CONSTRUCTION PLANS
FOR

NORTH VALLEY AREA I PHASE 2 AND AREA J SEWER PROJECT CABALLERO NORTE GRAVITY SYSTEM

Acknowledge receipt
APPROVAL OF RECORD DRAWINGS
CHIEF CONSTRUCTION ENGINEER
DATE 3/02/2007

REV.	SHEETS	CITY ENGINEER	DATE	USER DEPARTMENT	DATE	USER DEPARTMENT	DATE
1	All	AS-BUILT	11/16/06				
ENGINEERS STAMP & SIGNATURE				APPROVALS	ENGINEER	DATE	* * * * *
				DRC Chairman	William J. Balch	9-28-05	APPROVED FOR CONSTRUCTION
				Transportation	William J. Balch	9/28/05	
				Water/Wastewater	William J. Balch	9/14/05	
				Hydrology			
				C.I.P.			
				Constr. Mngmt.			City Engineer
				Constr. Coord.			
				City Project No.		763581	Sheet 1 of 17/19

TITLE: NORTH VALLEY AREA I PHASE 2 & AREA J SEWER PROJECT
CABALLERO NORTE GRAVITY SYSTEM
CABALLERO PARKWAY PLAN AND PROFILE STA 10+00 TO 15+80

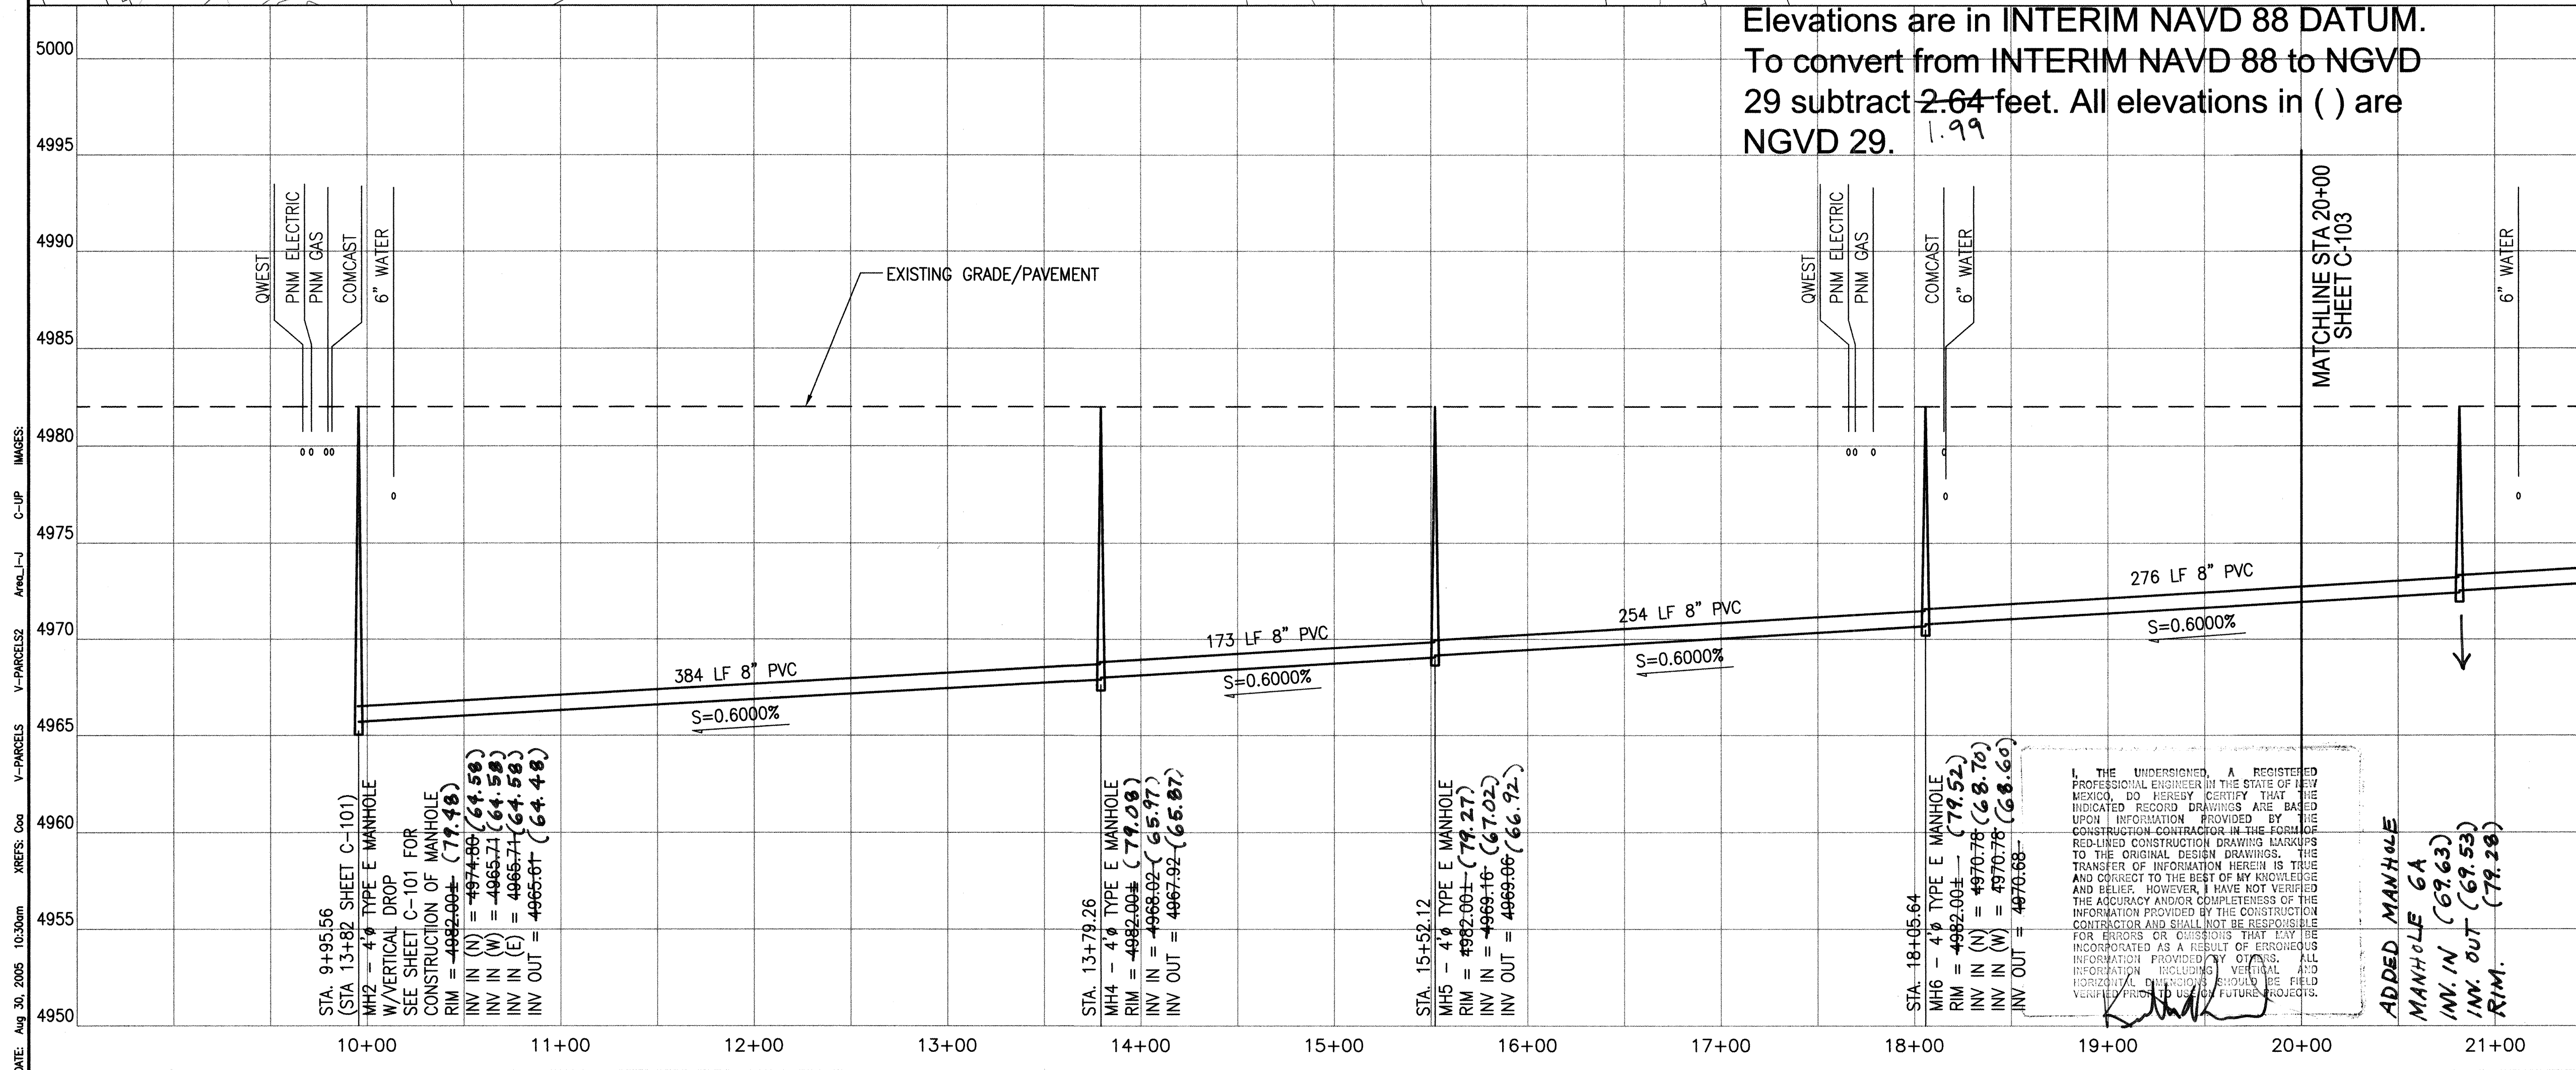
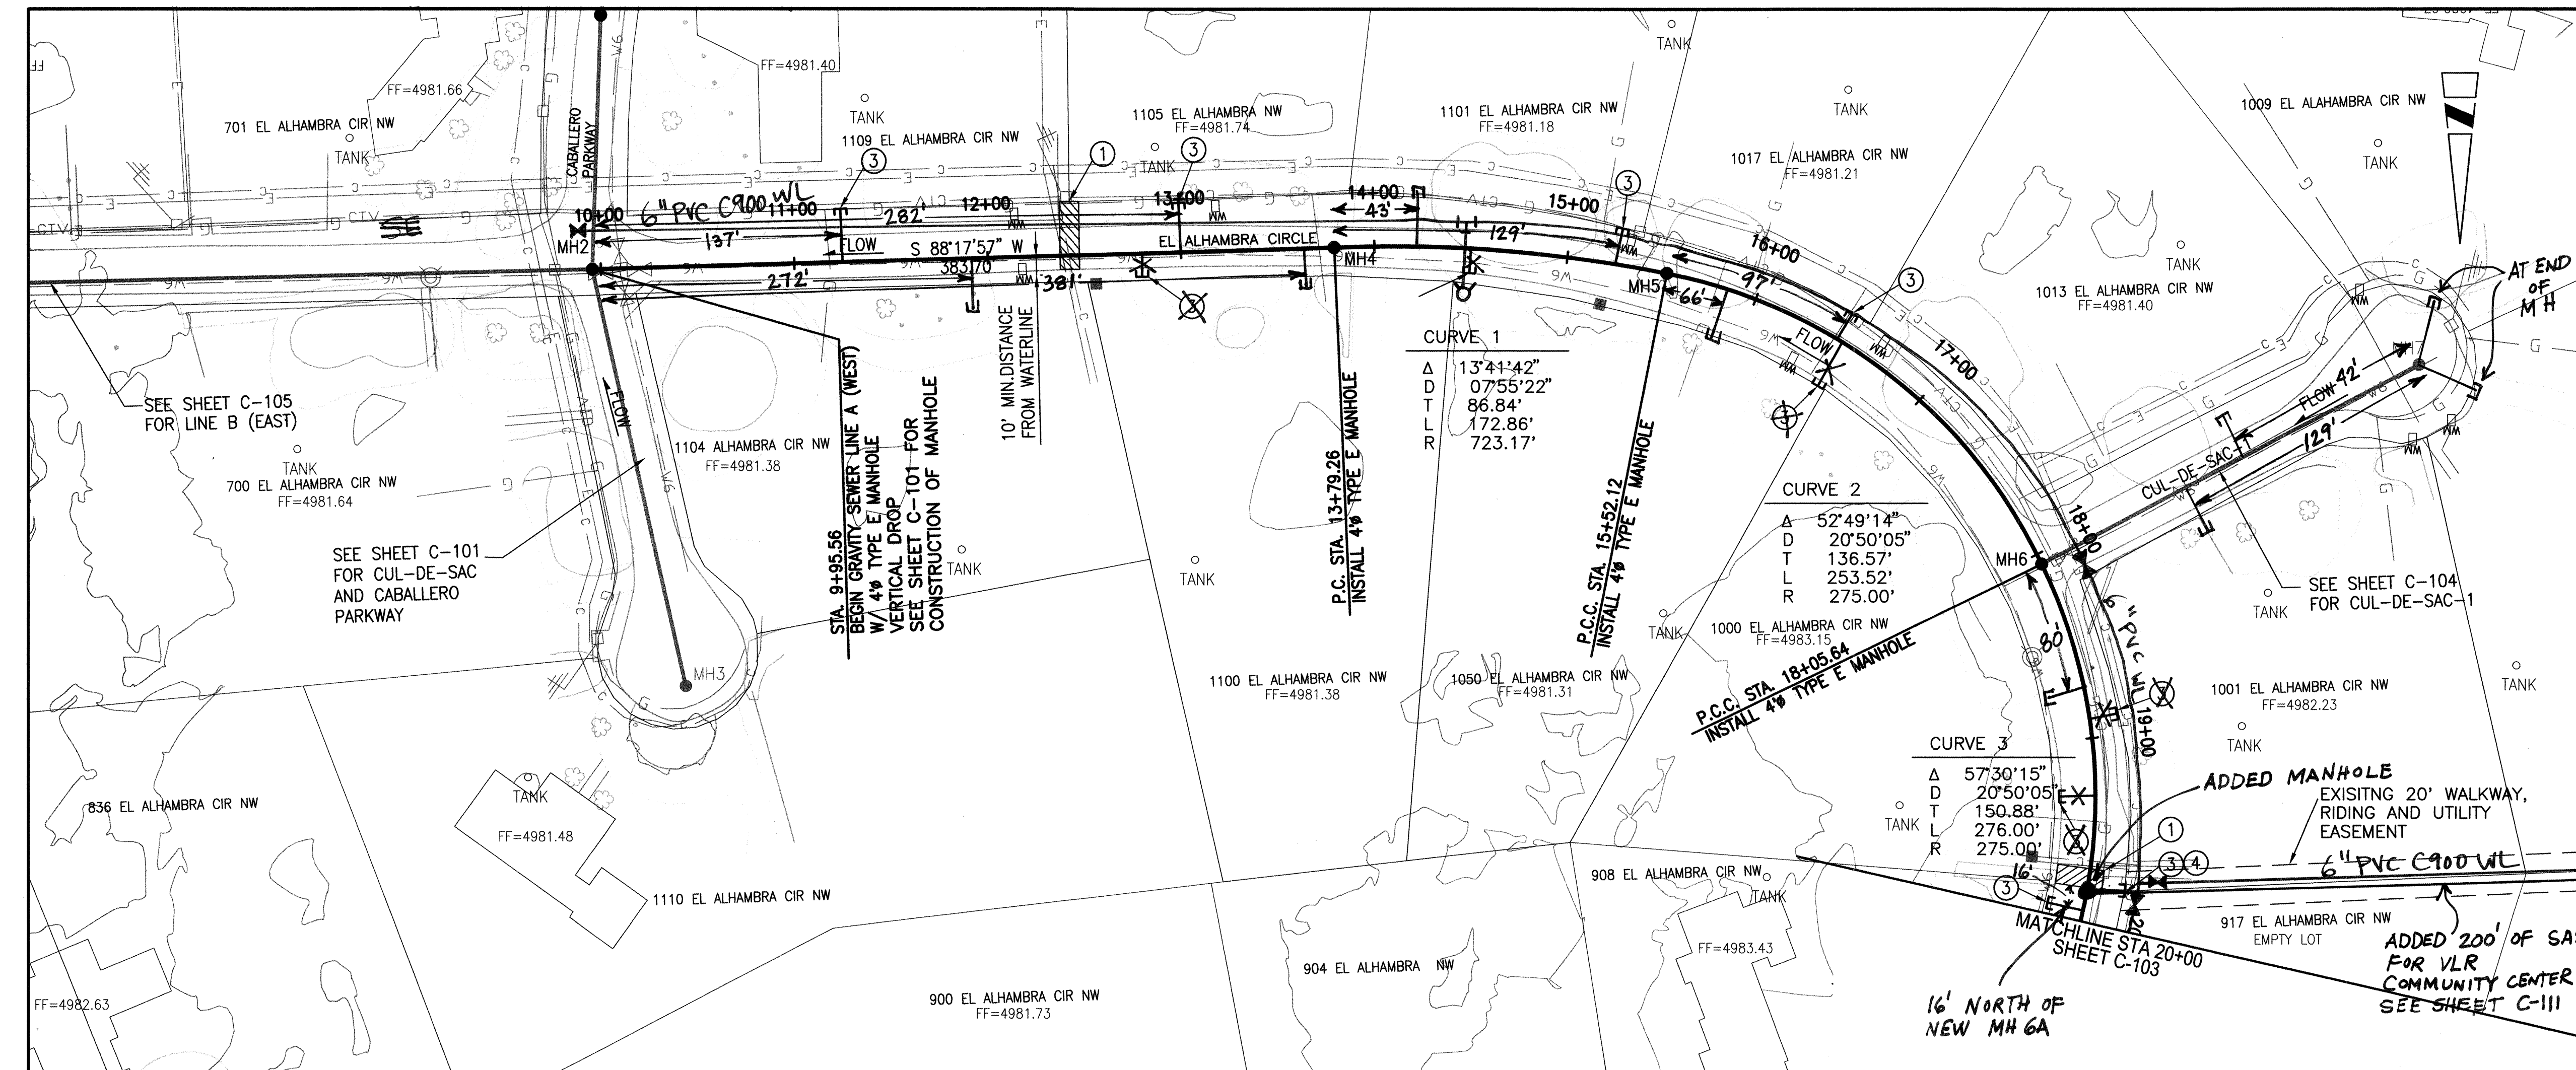
- DUE TO SEVERAL WL BREAKS CAUSED BY SAS CONSTRUCTION DISTURBANCE, THE CITY AUTHORIZED THE REPLACEMENT OF THE OLD ASBESTOS CEMENT WL BY THE CONTRACTOR VIA THEIR CALL UTILITY CONTRACT. OLD AC WAS TO BE REMOVED AND DISPOSED. MOST AC WAS ABANDONED IN PLACE. SEE PLANS FOR R+D LOCATIONS.
- FOR SEWER LAY OUT AS-BUILT WITH ~~NAVD 88~~ AND NGVD 29 ELEVATIONS AND MH COORDINATES SEE SHEET 5 (G-005) OF 19.
- ALL WATER METER SERVICE LINES AND BOXES WERE REHABILITATED.

NORTH VALLEY AREA I PHASE 2 & AREA J SEWER PROJECT
CABALLERO NORTE GRAVITY SYSTEM
NABOR ROAD LINE C PLAN AND PROFILE STA 10+00 TO 16+55

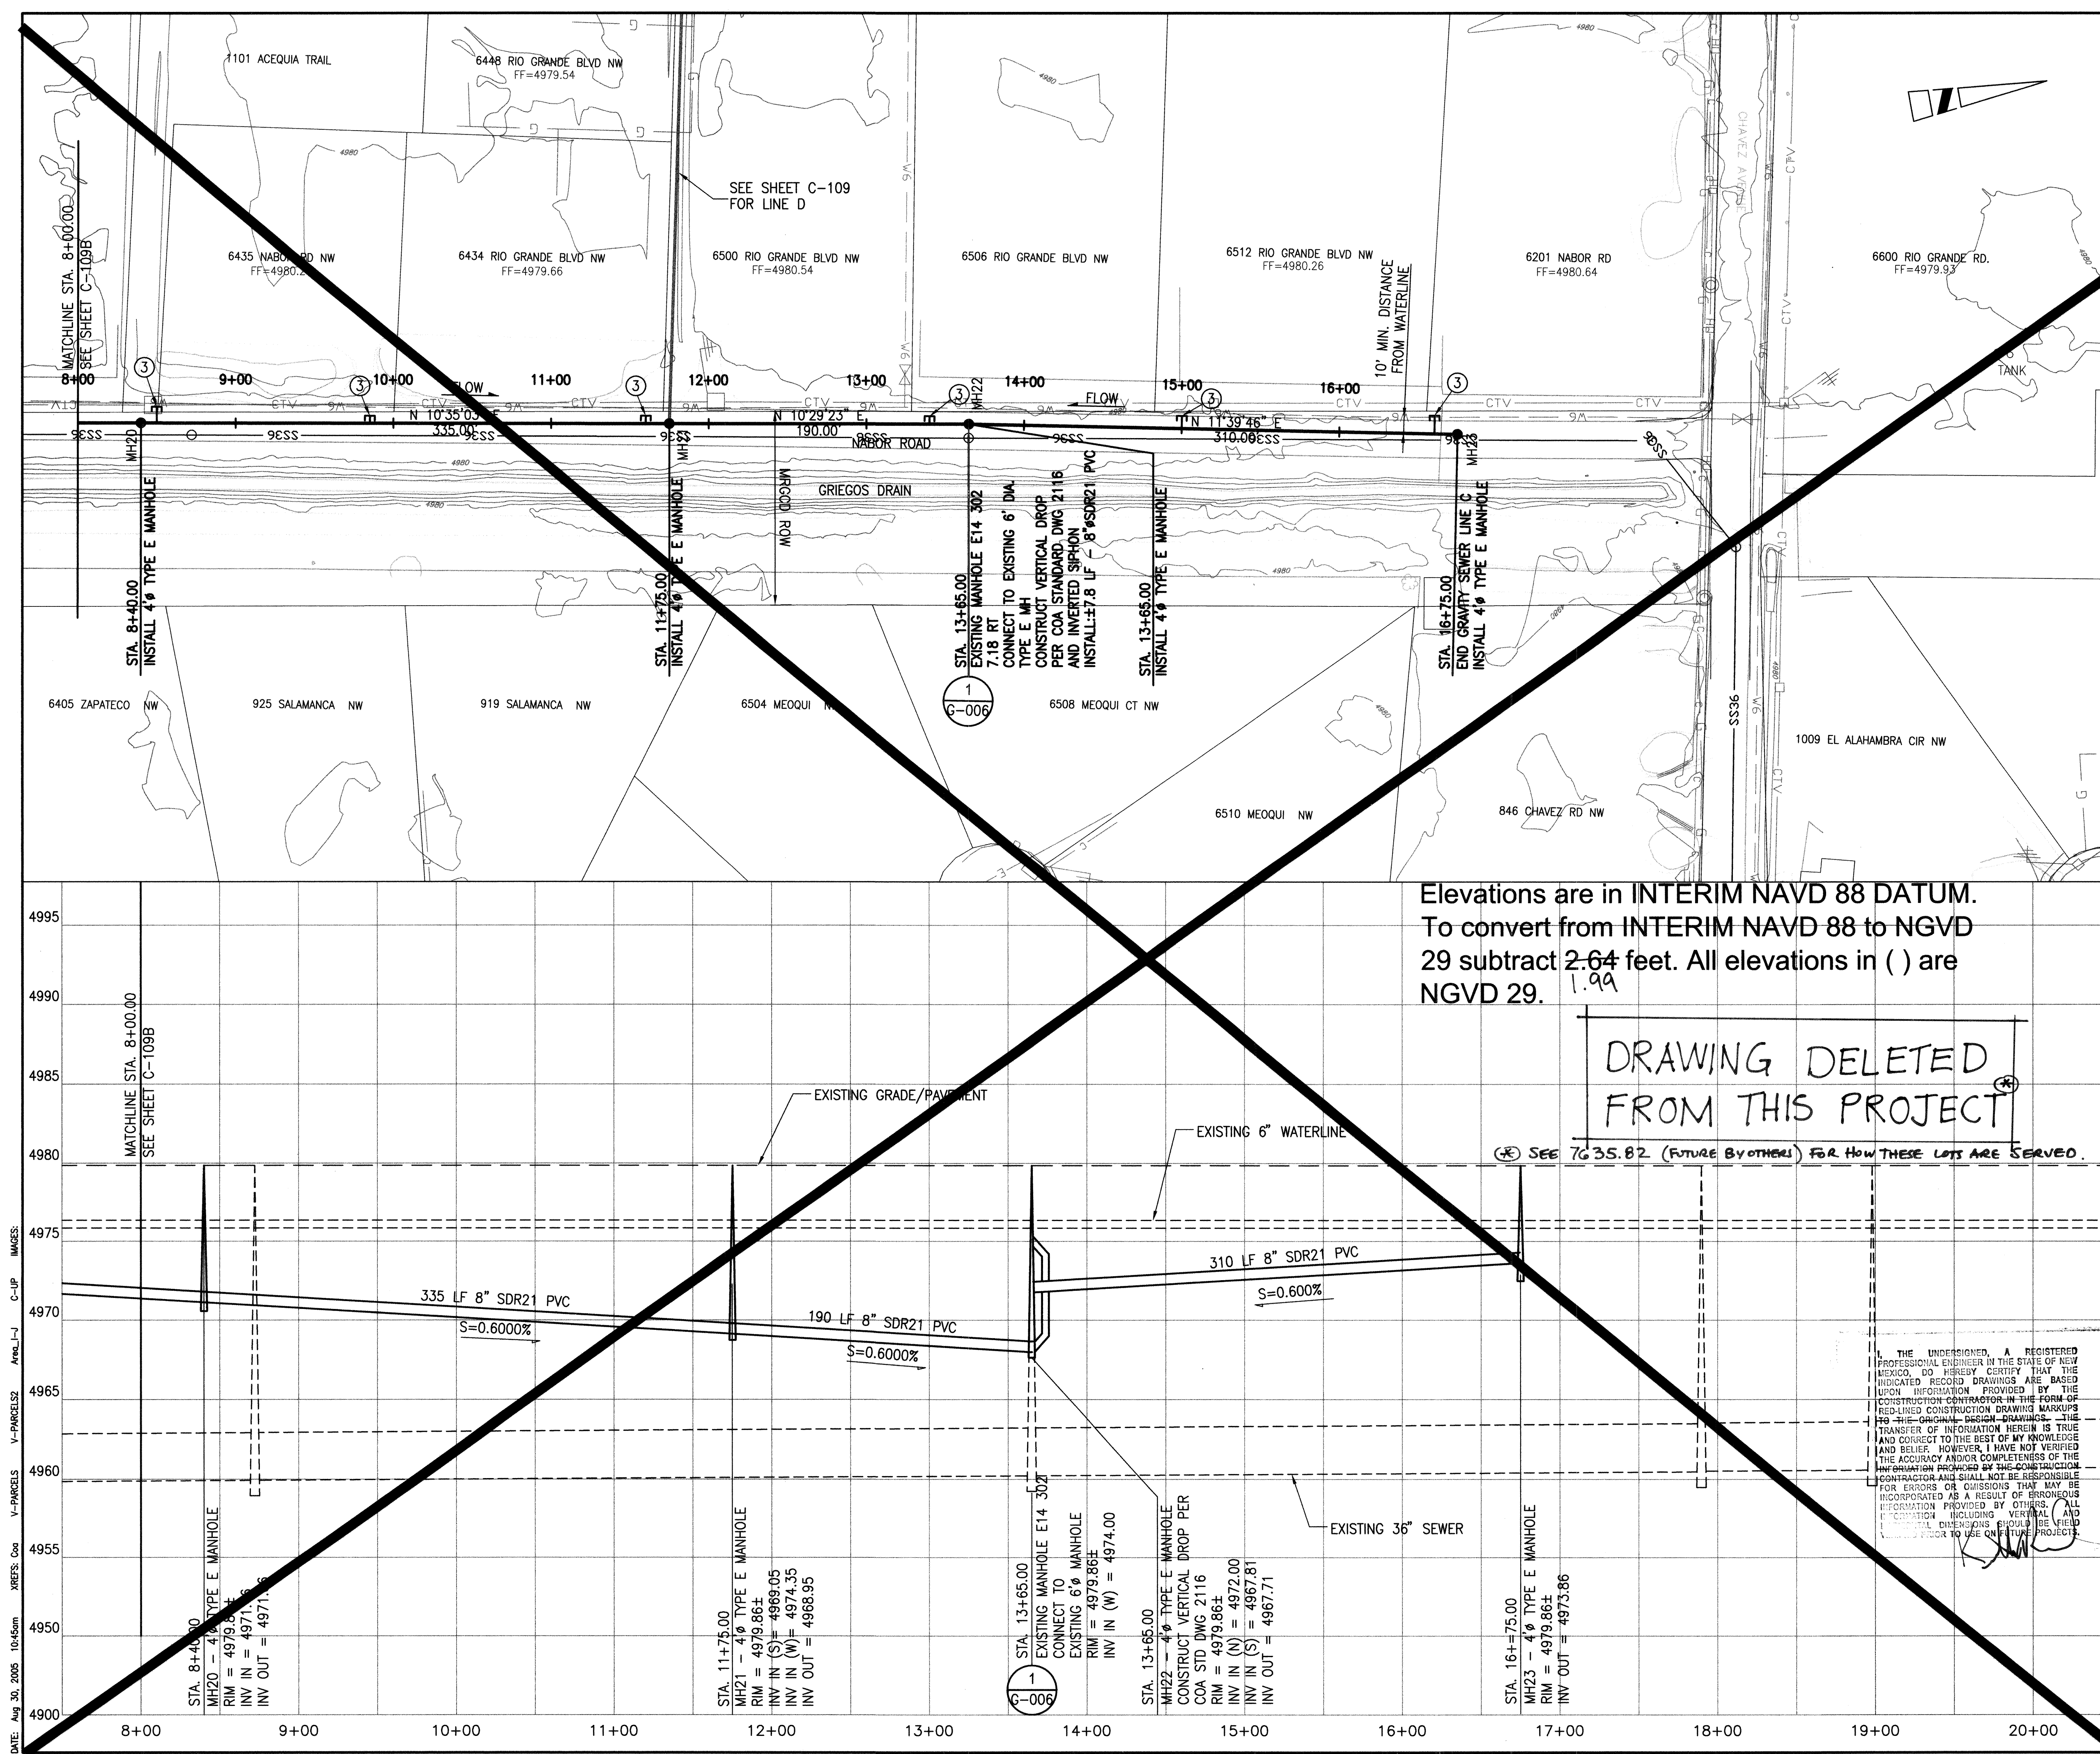
DRAWING DELETED FROM THIS PROJECT
